**Application No 2022/3352/HS2** (Proposed Euston Cavern Headhouse Park Village East NW1 7PX)

Objections [REDACTED], 8 Park Village East, London NW1 7PX.

My objections to HS2's planning application No 2022/3352/HS2 may be summarised as follows:

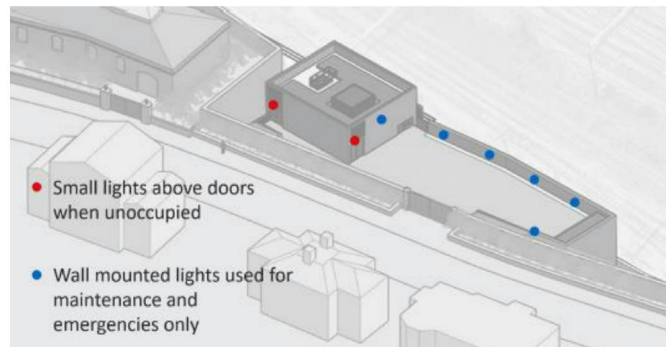
36. See the rendering in the Design and Access Statement at page 37. HS2 has not sought to justify the extravagant size of the gate.

As seen from the renderings above, the gate is more than twice the width of the van shown as parked in the parking area. It is over-dominant and unnecessarily wide.

The height of the PVE wall is approximately at 2.8m. Therefore, the light spillage from the site to the Park Village East road will be minimal (see Figure 38).

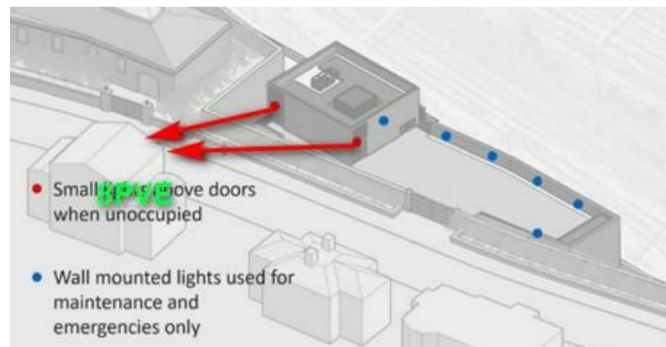
39. Light spillage to the road is one consideration. However this is a residential street and there will clearly be light spillage to the houses, particularly to bedrooms on the upper floors. My home at 8PVE will be affected, among others – my son and daughter-in-law's bedroom faces the street.

No consideration seems to have been given to light pollution to residents' bedrooms.

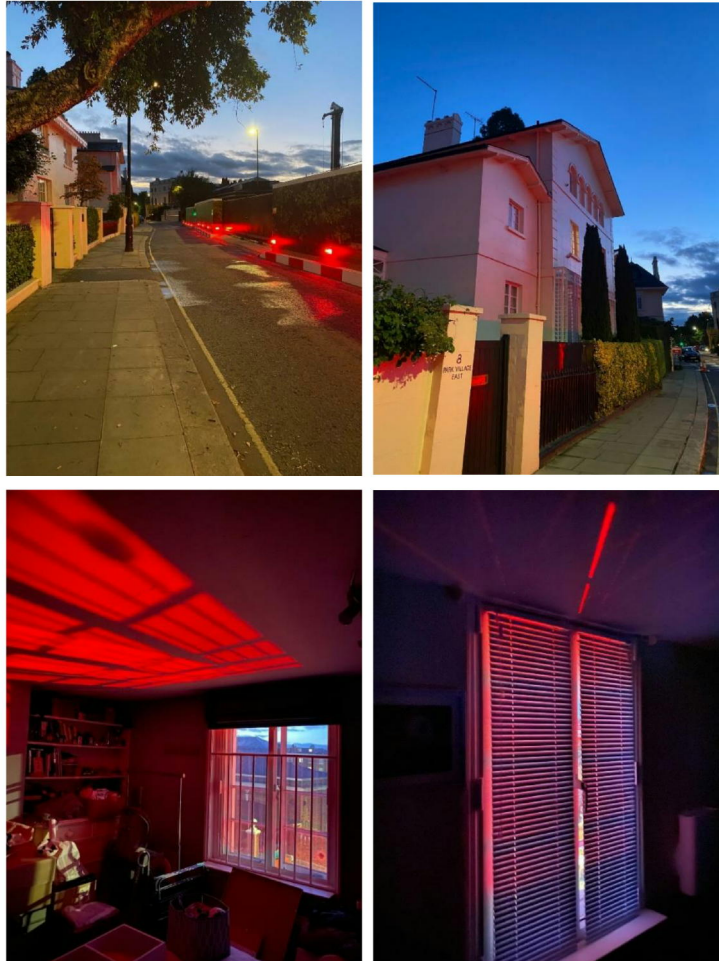
40. The text states "small lights above doors when unoccupied". There is no need for any such permanently on-at-night lighting at all when unoccupied. It is obtrusive and a needless waste of energy, meeting no requirement at all. The blue lights for emergencies suffice. This above-door lighting should be removed in its entirety.
